Wake County Office Building
12th & 14th Floor Upfit
Raleigh, North Carolina
March 13, 2025

ADDENDUM NO. 5
Page 1

HUFFMAN ARCHITECTS, PA
632 PERSHING ROAD
RALEIGH, NORTH CAROLINA 27608
PHONE (717) 644-1562

Design No. **I514**

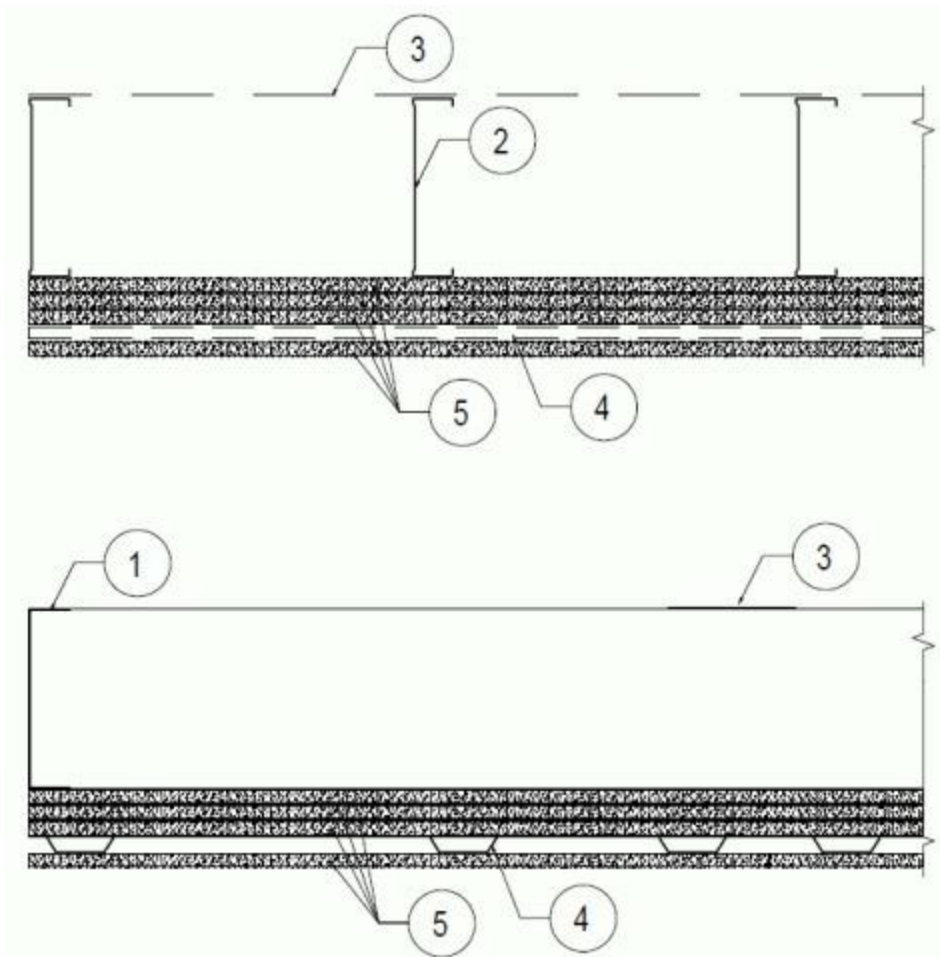
1. The project is currently anticipated to be under contract by the end of April, 2025, and is being allowed two hundred and ten (210) calendar days to be substantially complete.
2. Per Sheets A131 and A132 and Finish Tag Keynote #14, the Contractor shall install the B20 wood base only at exterior walls and exterior column wraps. The B20 base shall be installed at exterior walls and exterior column wraps only in those rooms indicated by Finish Tag Keynote #14, unless otherwise noted. The B20 base shall not be installed at interior walls or interior column wraps.
3. The Contractor shall reinstall a salvaged refrigerator into the 1402 Breakroom that has been stored elsewhere in the building.
4. The Contractor shall install a 2-hour rated ceiling assembly at the bottom of the shaft above and below new ducts in Telecom 1211. See the attached UL Detail I514.
